Wisconsin Department of Transportation

Proposal #10: 1100-45-70, WISC2023222
IH 41 Airport Freeway
84th Street to 35th Street (Mainline)
IH 41
Milwaukee County

1100-46-71, WISC2023223
IH 41 Airport Freeway
STH 36 (Loomis Rd) Bridge
IH 41
Milwaukee County

This is Addendum No. 01, which provides for the following:

| GENERAL NOTES AND QUANTITIES | | SHEET 3 OF 37 | 461 |

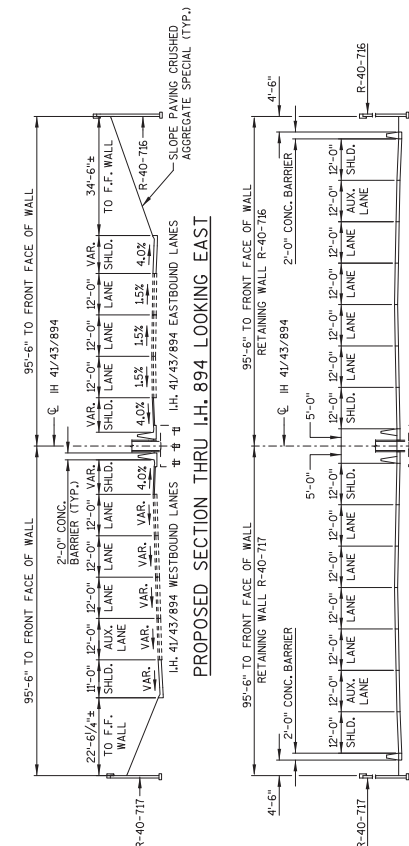
| Revised Plan Sheets – ID 1100-46-71 | |
|--|--|
| 461 | Structure B-40-1025 (Added Bid Items: 205.0506.S.001 Excavation, Hauling, and Disposal of Creosote Contaminated Soil – Daily Cover and 205.0506.S.002 Excavation, Hauling, and Disposal of Creosote Contaminated Soil – Direct Landfill) |

| 1 | 6/30/23 | ADDED BID ITEMS | MJA |

| BID ITEM NUMBER | BID ITEM DESCRIPTION | UNIT | SOUTH APPROACH | SOUTH ABUTMENT | PIER | NORTH ABUTMENT | NORTH APPROACH | SUPER | TOTALS |
|-----------------|--|------|----------------|----------------|-------|----------------|----------------|---------|-------------|
| 203.0500 S. 001 | EXCAVATION, HAULING, AND DISPOSAL OF CREGOSITE CONTAMINATED SOIL - DAILY COVER | TON | 1,319 | 1,319 | | 1,319 | | | 2,638 |
| 203.0500 S. 002 | EXCAVATION, HAULING, AND DISPOSAL OF CREGOSITE CONTAMINATED SOIL - DIRECT LANDFILL | TON | 147 | 147 | | 147 | | | 294 |
